Memorandum

Petitioner: Renae L. Julson and Linda M. Wheeler, Joint Owners

Subject: Variance Request to Permit and Install a New Individual Sewage Disposal System (ISDS) on an Undersized Lot Served by an Off-Site Public Water Supply with a Deep Absorption Trench within Twenty (20) Feet of a Structure and Ten (10) Feet of the Property Lines (APN 129-36-111-034)

140 Parcels permitted for a septic system within 1 circular square mile of the parcel 129-36-111-034

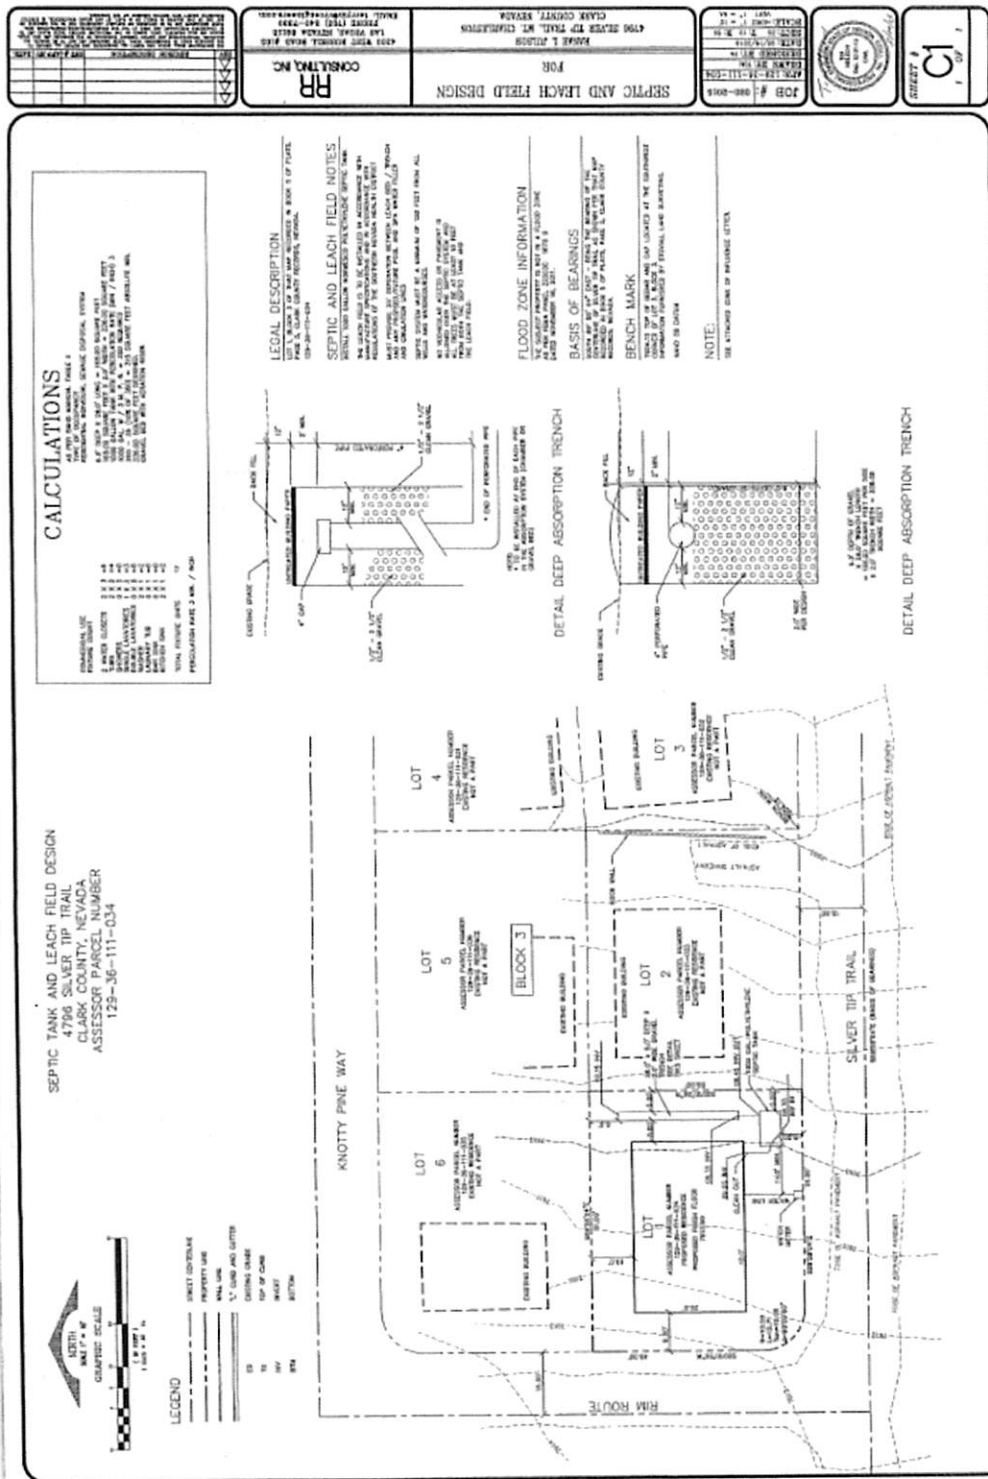
The ISDS density map also shows 140 Lots with a traceable permit for a septic system within a square mile of APN 129-36-111-034. The offsite water quality will not be affected by the proposed septic system. The closest neighboring building to the proposed ISDS is a distance of fifteen (15) feet, which is less than the normal twenty (20) feet minimum required separation, but acceptable per attached Cone of Influence Letter dated May 17, 2015 by Landon Christopherson, P.E. of DL Consulting. The closest property line is five (5) feet from the ISDS where ten (10) feet minimum separation is normally required.

Enlarged Plot Plan

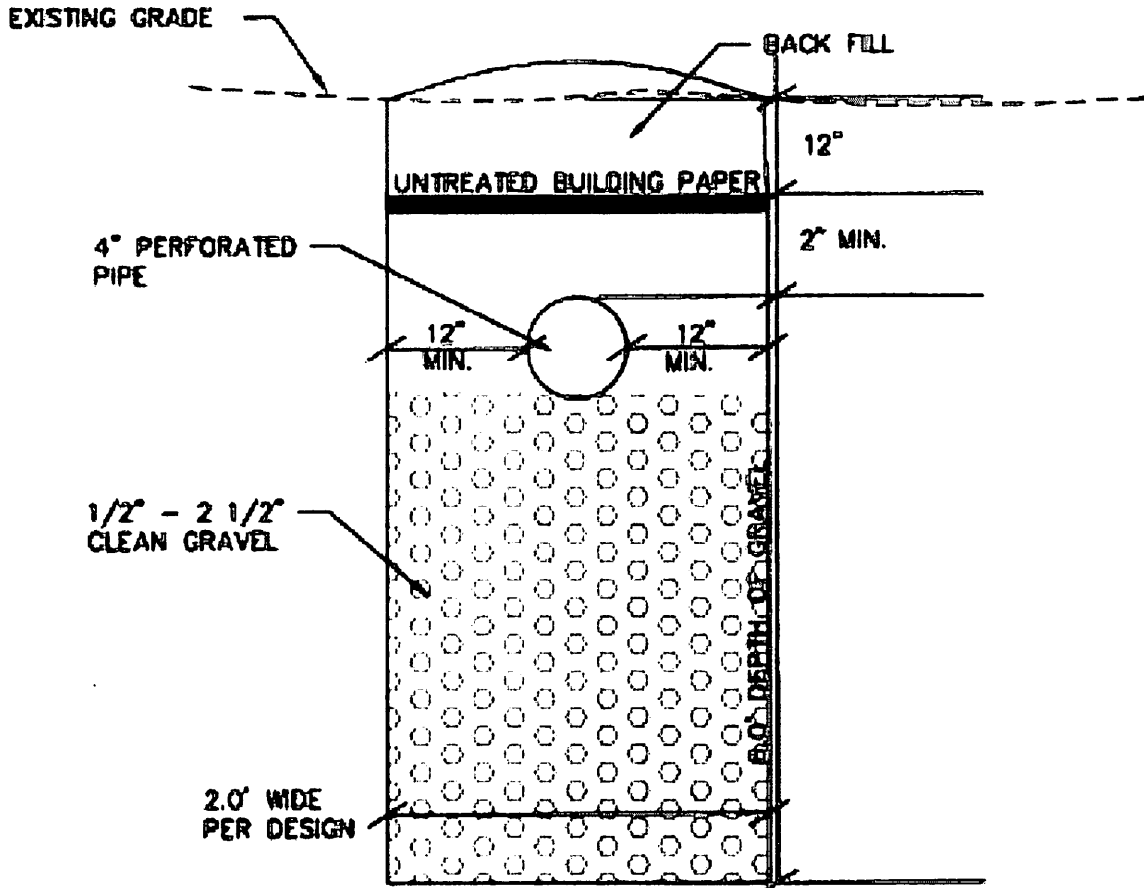
This variance request is made to permit construction of an ISDS on a lot 3,049.20 sq. ft. The septic tank is to be located 5 ft. from the proposed structure and no closer than 5 ft. from the nearest property line.

Based on this review, assessment of the building's structural envelope, and septic system data for the subject site, DLC Consulting believes that placement of the septic tank and field at approximately 4 feet from the structure does not impact the structural envelope of the site structure, nor does the structural envelope of the site structure affect the operation of the septic tank and field.
